RE: Hydrogeologic Review of Proposed Quarry Site in Albion

At your request, the following provides the findings of a technical evaluation of the potential hydrogeologic impacts of the proposed quarry site in Albion, Wisconsin.

FIGURE 1.

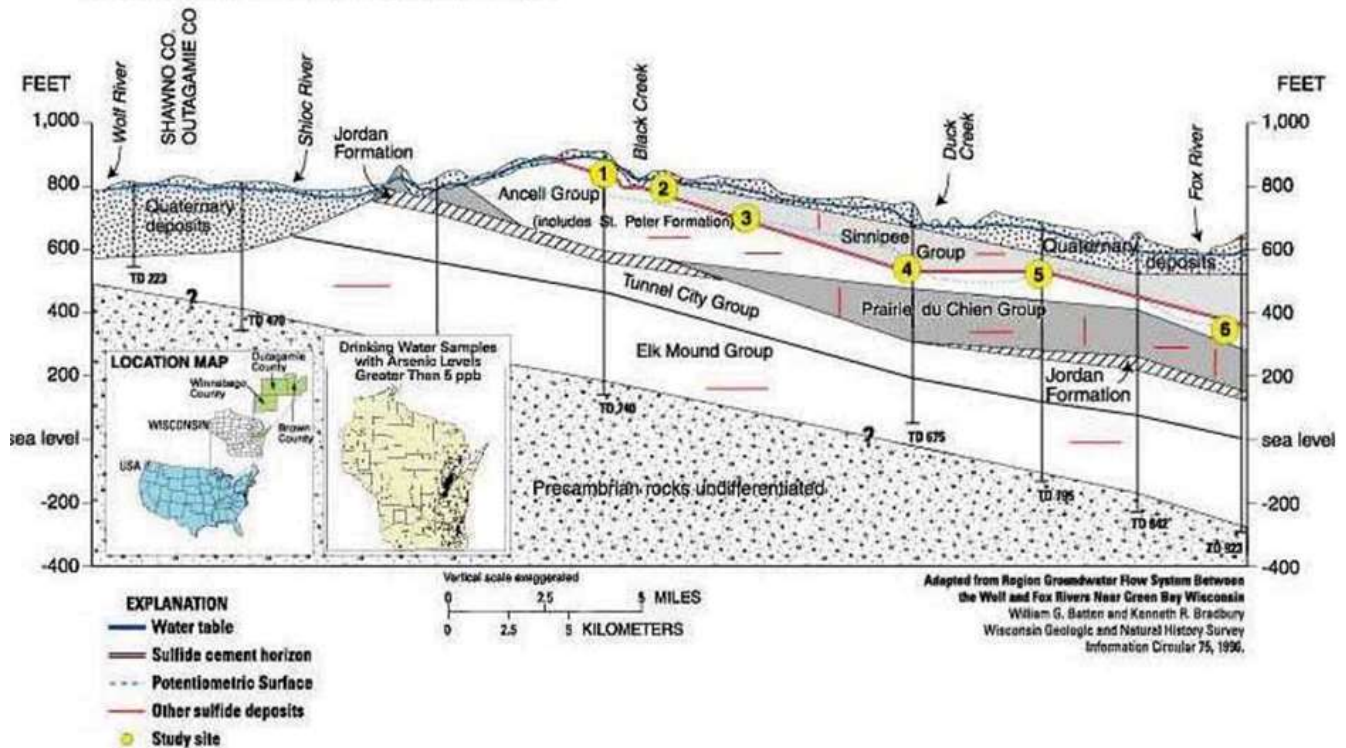
There is a significant potential for arsenic to be mobilized into groundwater from quarry operations. Sulfides and metal oxides within the lower section of the Platteville formation and upper section of the St Peter Sandstone are known to be intruded by sulfide deposits, and have been found to cause significant arsenic issues in several areas of the state.

Documentation by the Department of Natural Resources indicates arsenic is commonly found in the Platteville formation at the St Peter Sandstone (Figure 1). Processes for release of arsenic include oxidation, reduction, changes in pH, and changes in phosphate and silica.

Oxidation of the arsenic-bearing layer from quarry processes can result in the release and resultant mobilization of arsenic into the groundwater. As material is exposed to air or increased dissolved oxygen, ferrous sulfide minerals are affected by oxidative dissolution, sulfides are oxidized to sulfates, and arsenic is released.

FIGURE 2.
Water Table Elevations and Un lithified Aquifers
Dane County, Wisconsin
 Source: Hydrogeology of Dane County, Wisconsin, Wisconsin Natural
 History and Geological Survey, 1999.

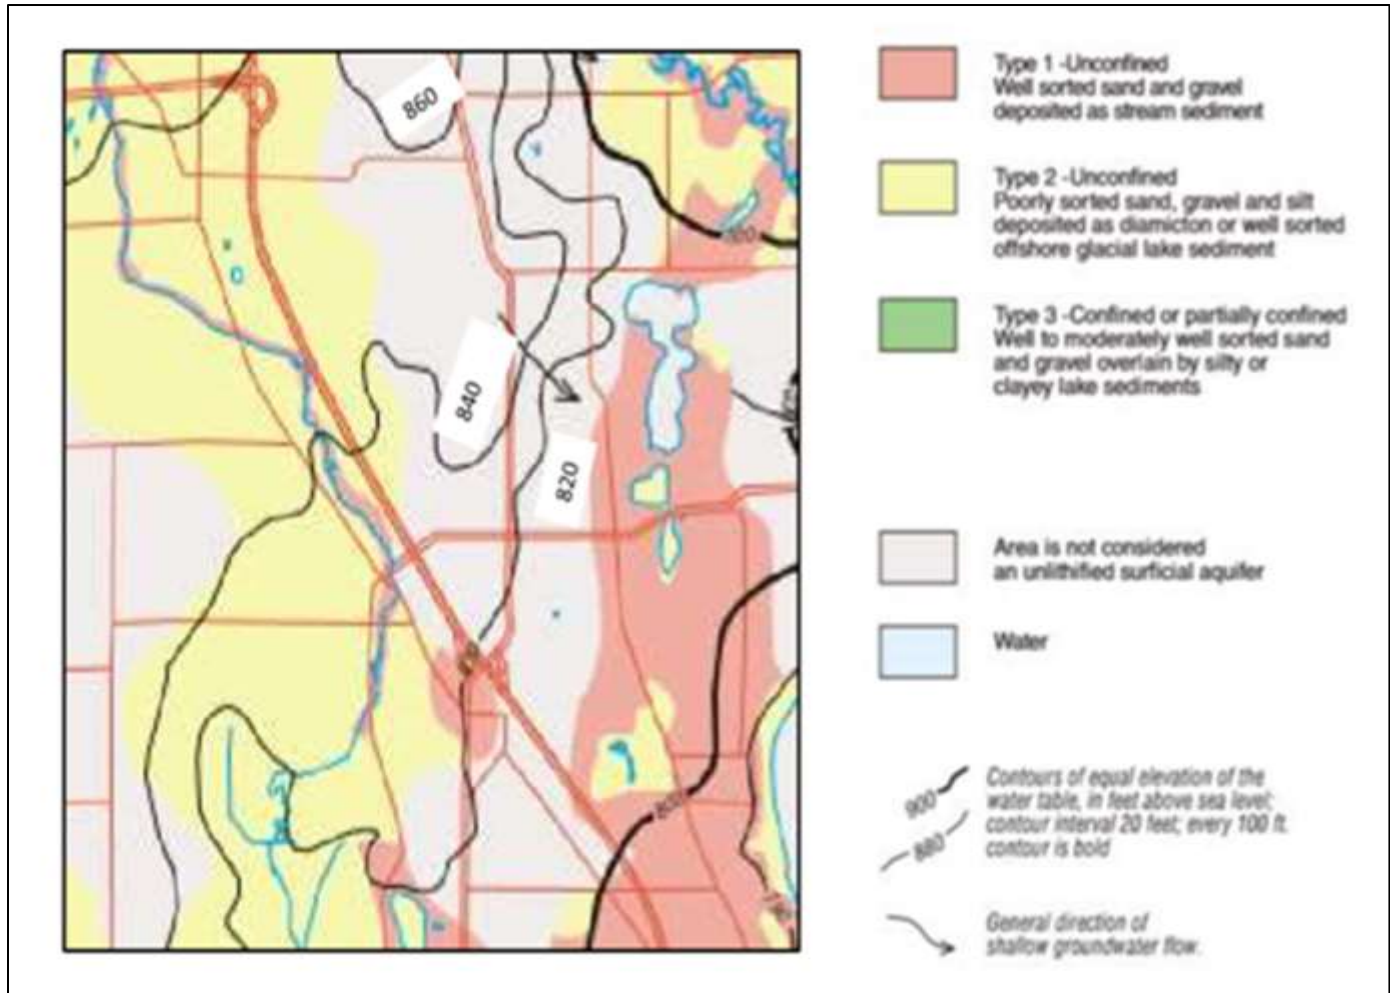
Groundwater levels in well construction reports are consistent with the groundwater levels expected across the area, with depth to water greater north and east of the proposed quarry site. Water levels become more shallow south and southwest of the site. An illustration of the water levels is provided in Figure 2.

The application materials reviewed as part of this review identify the quarry floor to be estimated at 850 msl. This estimate puts the base of quarry operations at or near the water table. Water supply wells could be significantly impacted by the proposed quarry if quarry operations go beyond the current proposal of 850 msl.

Application materials identify the depth to groundwater as 96 feet bls. Based on the technical evaluation conducted, it appears unlikely that the depth to groundwater in the area of the proposed quarry is this deep.

The Hydrogeology of Dane County (Open File 1999-04, Wisconsin Natural History and Geological Survey, Plate 1) provides a summary of water levels and groundwater flow within Dane County based on an evaluation of well construction reports. The study indicates shallow groundwater flow beneath the proposed quarry area toward the southeast. Water level elevations in the area range from less than 840 mean sea level (msl) in the southwest quadrant of the proposed quarry to 860 msl north of Craig Road.
